Access Compliance Report

Public Rights-of-Way

(Curb Ramps)

Intersection ID: 11043	Main Street: BRIARHILL_DR	Cross Street: MILTON_RD	Location:	W
ADA ID: C6844EDE8A83	Ramp Type: PerpDiag	Initial Pass/Fail: Fail	Overall Compliance: No	Severity Score: 30
Codes/Mitigation Info/Possible Solution		Field Measurements/Component Compliance

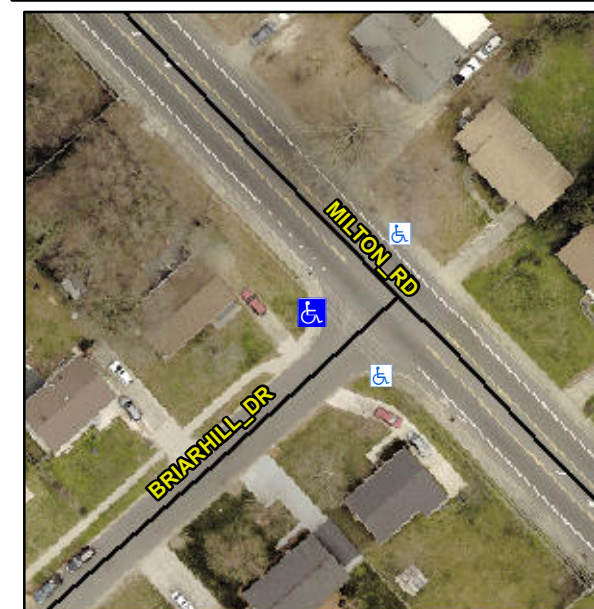
Not Found, R304.5.1, R304.2.2

Compliance	Description	Data	Compliance	Description	Data
N/A	Ramp Length (in)	59.0	No	Ramp Slope (%)	9.4
No	Ramp Width (in)	33.5	Yes	Ramp XSlope (%)	0.8
N/A	Flare Type LT	N/A	N/A	Flare Type RT	N/A
N/A	Flare Slope LT (%)	N/A	N/A	Flare Slope RT (%)	N/A
N/A	Flare Traversable LT?	N/A	N/A	Flare Traversable RT?	N/A
N/A	Landing Length (in)	N/A	N/A	DWS Provided?	N/A
N/A	Landing Width (in)	N/A	N/A	DWS Contrast?	N/A
N/A	Landing Slope (%)	N/A	N/A	DWS Length (in)	N/A
N/A	Landing X Slope (%)	N/A	N/A	DWS Full Width?	N/A
N/A	Landing Curb? (Y/N)	N/A	N/A	DWS Offset (in)	N/A
N/A	Shared Landing?	N/A			
N/A	Gutter Ponding?	N/A	N/A	Gutter Slope (%)	N/A
N/A	Gutter Lip Ht (in)	N/A	N/A	Gutter X Slope (%)	N/A
N/A	Painted X Walk1?	No	N/A	Painted X Walk2?	No
	X Walk 1 Direction	To SE		X Walk 2 Direction	To NE
N/A	X Walk 1 Width (in)	N/A	N/A	X Walk 2 Width (in)	N/A
	X Walk 1 Slope (%)	1.0		X Walk 2 Slope (%)	2.0
	X Walk 1 X Slope (%)	1.6		X Walk 2 X Slope (%)	0.9

Remove & Replace Curb Ramp With Two New Directional Ramps or Equivalent.
